ORIGINATION FORM -

Proposed Revisions to a Standard Plans Index

(Please provide all information — Incomplete forms will be returned)				
Contact Information:			Standard Plans:	
Date: February 10, 2020			Index Number: 630-010	
Originator: Cheryl Hudson			Sheet Number (s): 1	
Phone: 414-5332			Index Title: Conduit Details - Embedded	
Email: cheryl.hudson@dot.state.fl.us				
Summary of the changes:

CONDUIT DETAILS - EMBEDDED

630-010 1 of 4

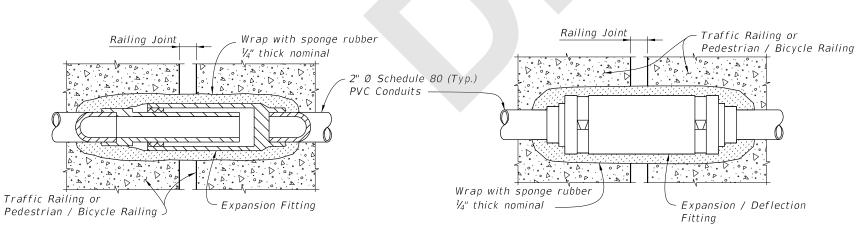
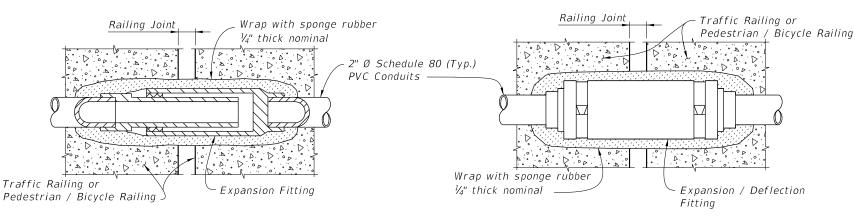
Sheet 1: Added Note 5				
Commentary / Background:				
See plans for number of conduits - per SDG				
Other Affected Offices / Documents: (Provide name of person contacted)				
Yes	No			
		Other Standard Plans –		
		FDOT Design Manual –		
		Basis of Estimates Manual –		
		Standard Specifications –		
		Approved Product List –		
		Construction –		
		Maintenance –		
		n Package Includes: nd deliver package to Rick Jenkins)		Implementation: ☐ Design Bulletin (Interim)
Yes	N/A	ind deliver package to filek Jehkins)		DCE Memo
	✓✓	Redline Mark-ups		Program Mgmt. Bulletin
		Proposed Standard Plan Instruction (SPI)		FY-Standard Plans (Next Release)
		Revised SPI		
	\checkmark	Other Support Documents

- 5. Place conduits as indicated in this Standard unless the Structures Plans show fewer.

- 5. Place conduits as indicated in this Standard unless Structures Plans indicate fewer.
